CITY OF MOBILE
Lighting for Japanese Gardens and Segment 1 of the Three Mile Creek Greenway Trail
Project No. 2025-2045-01

ADDENDUM 1

This addendum includes the following:

23. FYI – Poles are 10 – 12 weeks lead time as well

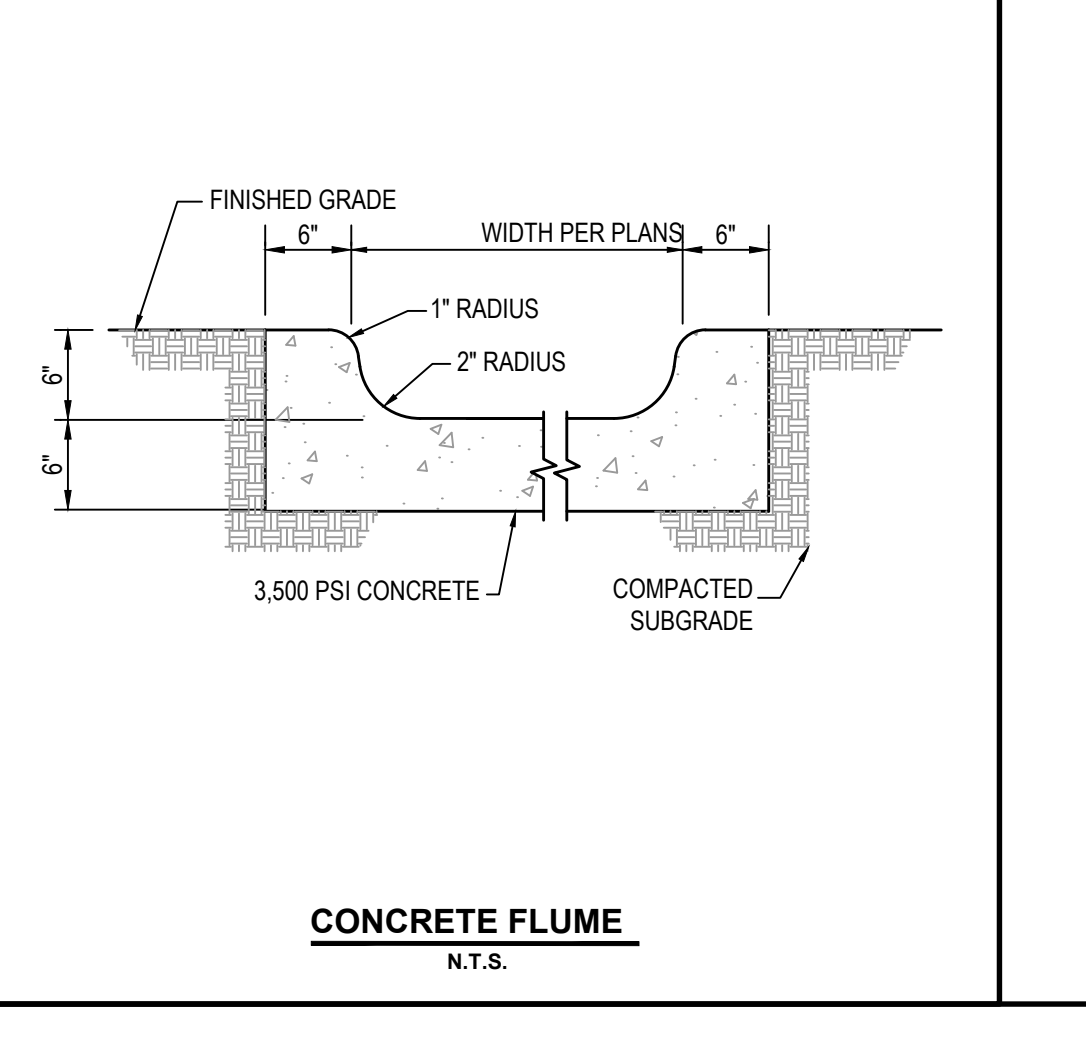
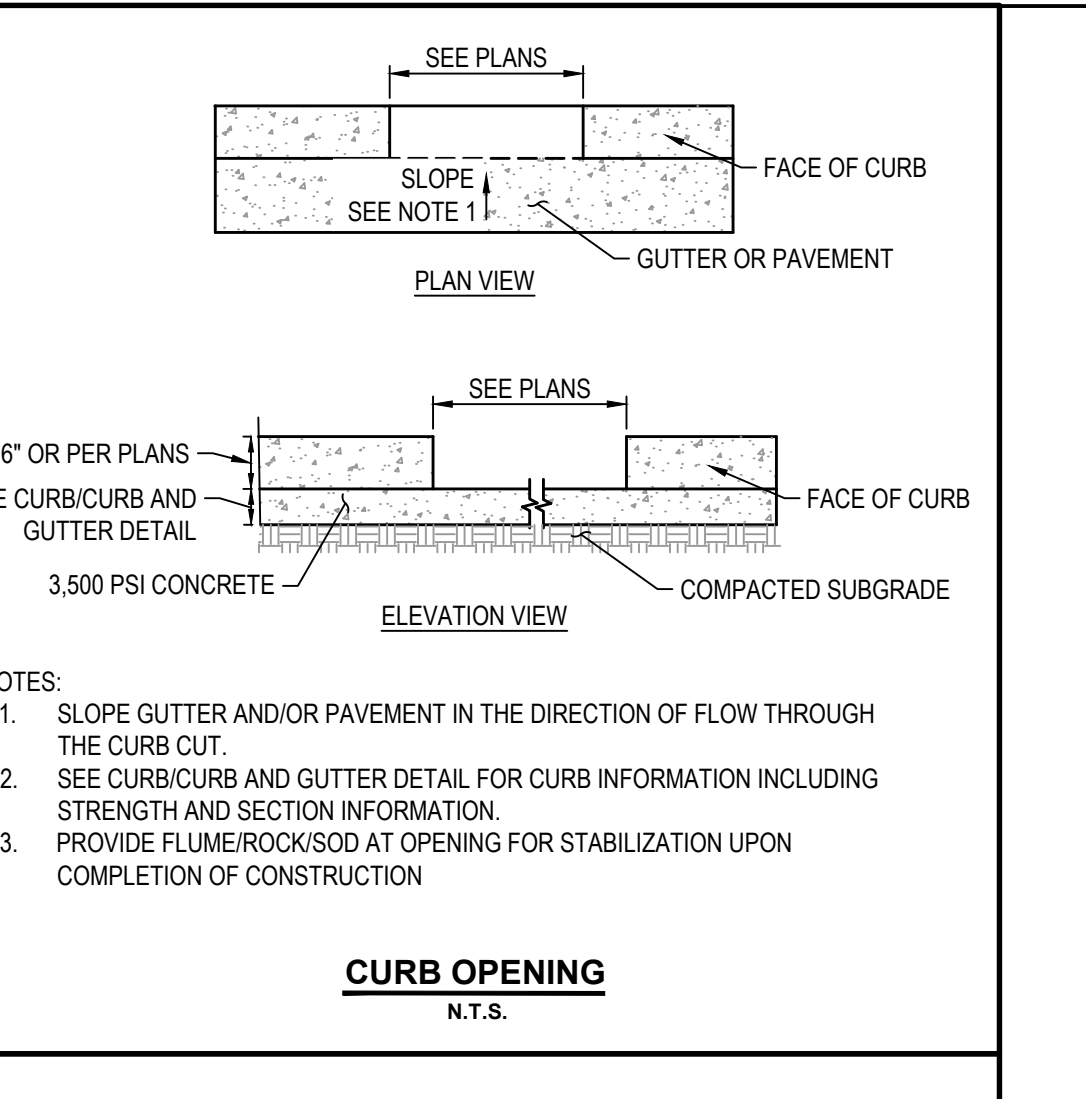
19. Please provide the build-up and typicals for the walking path and ribbon curb along the trail for informational purposes

See Attachment A.
